ADMINISTRATIVE AMENDMENT (FPA) ADD2015-00132**ADMINISTRATIVE AMENDMENT
LEE COUNTY, FLORIDA**

WHEREAS, Miromar Lakes, LLC filed an application for Final Zoning Plan Approval (FPA) to a Mixed-Use Planned Development (MPD) on a project known as The Peninsula Phase IV at Miromar Lakes to allow:

FINAL PLAN APPROVAL THE PENINSULA PHASE IV AT MIROMAR LAKES A PORTION OF STRAP # 13-46-25-00-00001.0030 LEE COUNTY, FLORIDA

Case: ADD2015-00132

FINAL PLAN

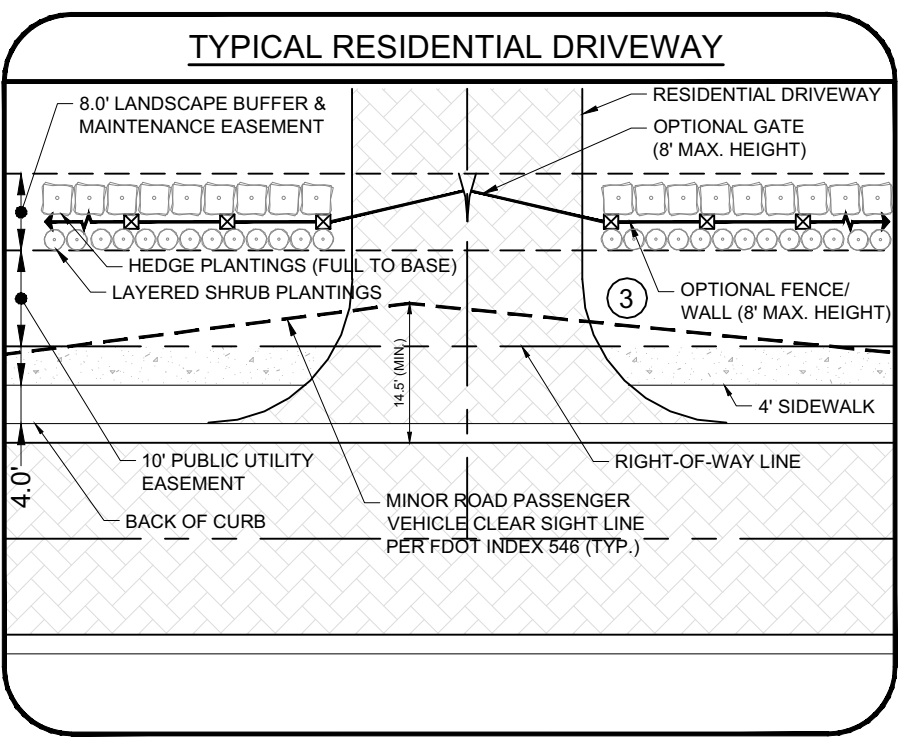
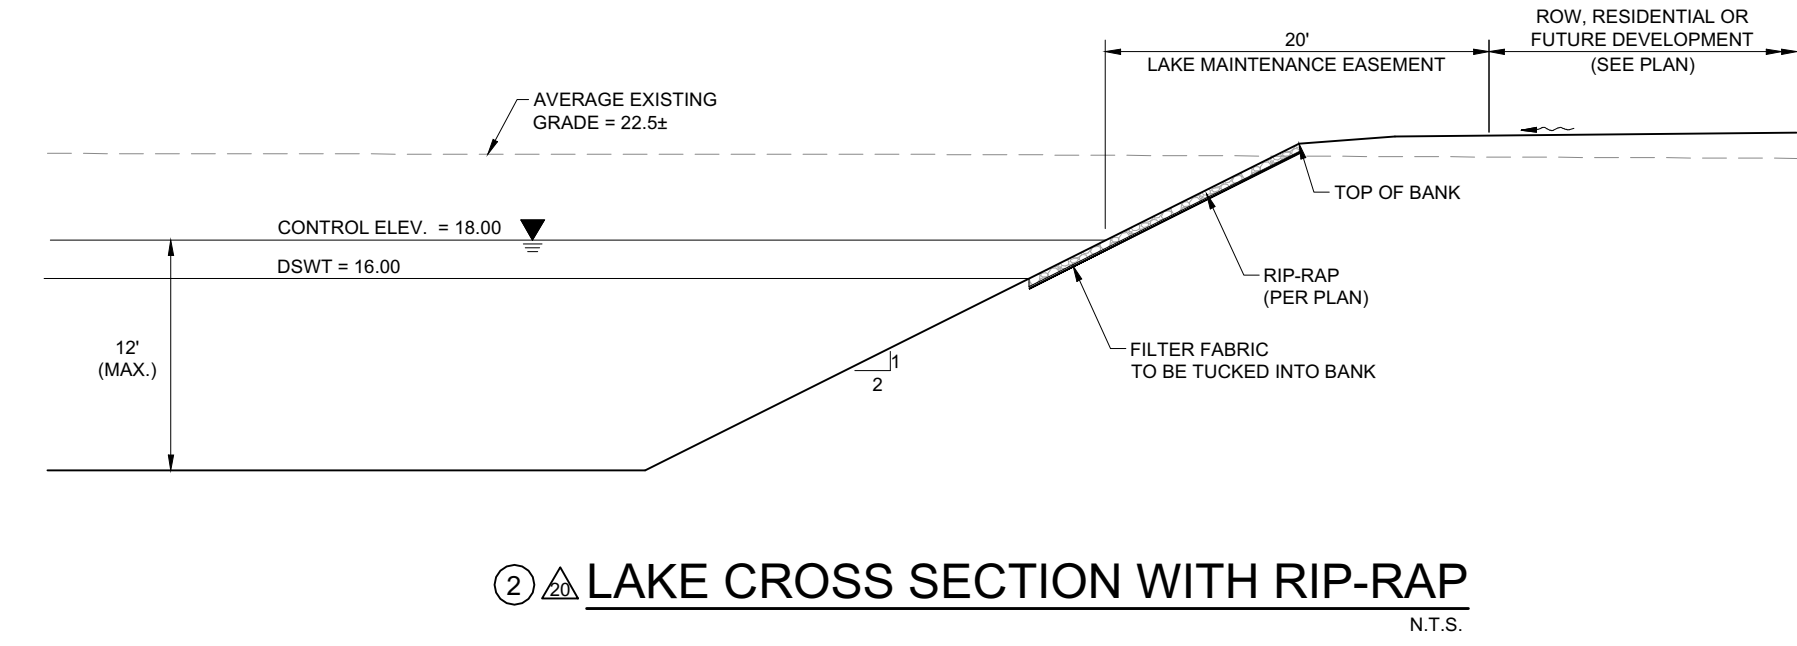
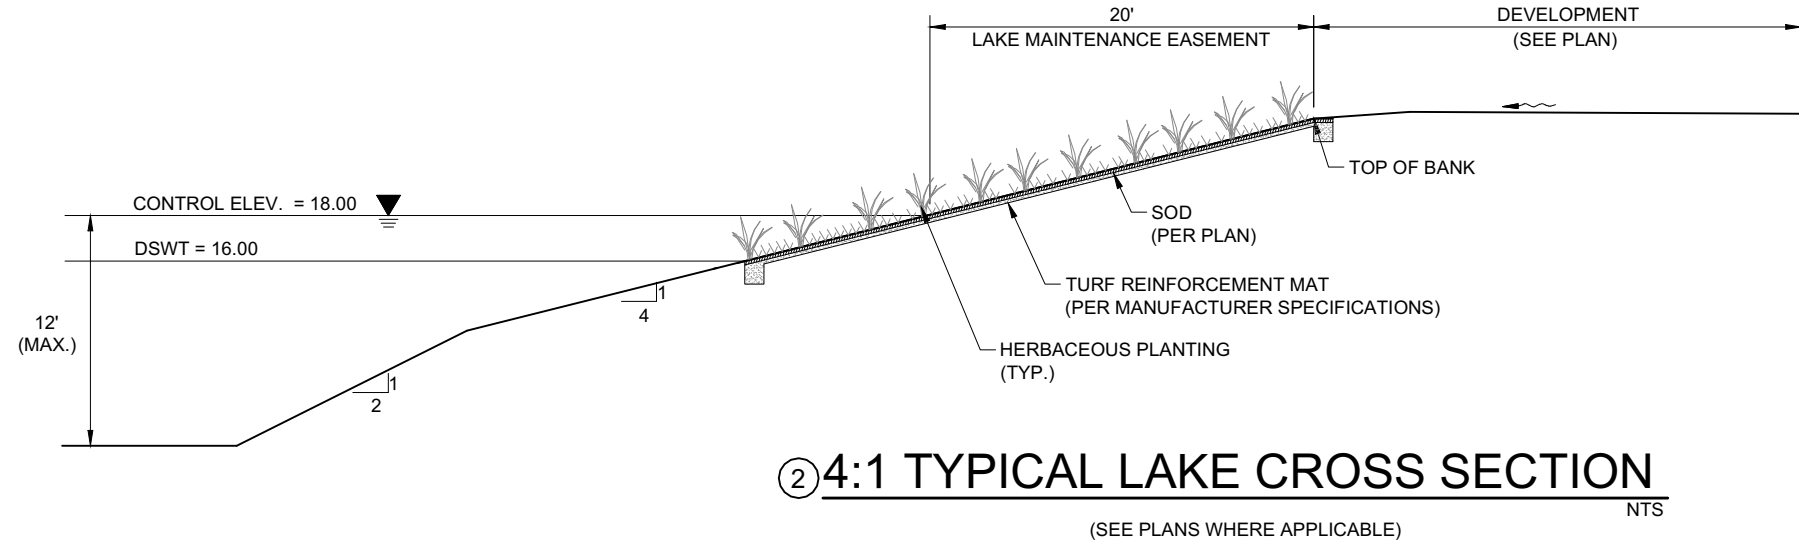
3. Deviation #2 from LDC Sec. 10-329(d)(4) which requires lake banks to be sloped at a 6:1 ratio from the top of bank to a water depth of two feet below the dry season water table, to allow for a minimum ratio of 4:1 where turf reinforcement mat is proposed, and a minimum ratio of 2:1 where rip-rap shoreline is proposed (Approved per ADD2014-00102) ; and

5. Deviation #4 from LDC Sec. 10-418(3) which allows riprap revetments or other similar hardened shoreline structures to comprise up to 20% of an individual lake shoreline, but cannot be used adjacent to single-family residential uses, to allow for riprap to be adjacent to single-family residential uses within lots 1-22 and 34-56 (Approved per ADD2014-00102 with a different lot configuration); and

6. Deviation #5 from LDC Sec. 10-296(p)(1) which requires dead-end streets to be closed at one end by a circular turnaround for vehicles, to allow a dead-end at the south terminus of Via Lugano Court (new request); and

7. Deviation #6 from LDC Sec. 34-1954(b)(2) to allow for dry models on lots 6, and 46-48 (new request).

ADD2015-00070 FPA is being reviewed concurrently to address deviation requests to increase limits of allowable harden shoreline on the recreation lake, harden shoreline adjacent to single family residential uses, and the reduction in lake bank slopes where turf reinforcement mat and rip rap is used within the entire Miromar Lakes development. These deviation requests are all applicable to this project's shoreline as depicted on the Miromar Peninsula FPA.

ADD2015-00070 requests to deviate from LDC Section 10-418(3) which requires hardened shoreline structures may comprise up to 20 percent of an individual lake shoreline; to allow up to 65% of the shoreline on the developed portions of the north and south recreational lakes within the Miromar Lakes community at the time of this application to address the continued erosion of the shoreline. The Peninsula Miromar Phase IV plan depicts rip rap linear footage and location and required compensatory littoral areas B & C square footage and location consistent with ADD2015-00070 plans. The applicant would like to maintain the option to utilize turf reinforcement mats (non-harden shoreline) on a portion of the shoreline but has requested the worst case scenario as part of the deviation. Environmental staff recommends regardless of whether turf reinforcement mat or rip rap is proposed compensatory littoral areas are to be installed and planted per ADD2015-00070 approvals.

ADD2015-00070 requests to deviate from LDC Section 10-418(3) which prohibits the use of harden shoreline adjacent to single family uses; to allow for the placement of rip rap adjacent to single family lots. The Peninsula Miromar Phase IV plan depicts proposed rip rap adjacent to single family lots 1- 22 and 34-56.

ADD2015-00070 requests to deviate from LDC Section 10-329(d)(4) which requires lake banks to be sloped at a 6:1 ratio from the tip of bank to a water depth of two feet below the dry season water table; to allow 4:1 slopes where turf reinforcement mats are used or 2:1 slopes where rip rap is used. The Peninsula Miromar Phase IV provides typical cross sections to illustrate slopes if turf mats or rip rap is proposed. Environmental staff recommends that at the time of local development order if rip rap is proposed it must be consistent with the more detailed design specifications of ADD2015-00070. If turf reinforcement mats are proposed then the turf reinforced lake bank cross sections must depict at minimum 1-gallon littorals installed at a minimum 2-feet on centers, from a minimum 2-feet below control to 4-feet above control as enhancements required by LDC Section 329(d)(4).

1. **The development must be in substantial compliance with the Final Zoning Plan per Attachment "A".**
2. **The developer must install signage at the nearest intersection to notify vehicles and emergency responders of the dead-end.**

3. **Development order plans must depict compensatory littoral areas are to be installed and planted per ADD2015-00070 approvals regardless of whether turf reinforcement mat or rip rap is proposed.**

4. **Development order landscape plans must depict any proposed rip rap shoreline to be consistent with and not to exceed the more detailed design specifications of ADD2015-00070. If turf reinforcement mats are proposed then the turf reinforced lake bank cross sections must depict at minimum 1-gallon littorals installed at a minimum 2-feet on centers, from a minimum 2-feet below control to 4-feet above control.**

Development order plans must depict compensatory littoral areas are to be installed and planted per ADD2015-00070 approvals regardless of whether turf reinforcement mat or rip rap is proposed.

Development order landscape plans must depict any proposed rip rap shoreline to be consistent with the more detailed design specifications of ADD2015-00070. If turf reinforcement mats are proposed then the turf reinforced lake bank cross sections must depict at minimum 1-gallon littorals installed at a minimum 2-feet on centers, from a minimum 2-feet below control to 4-feet above control.
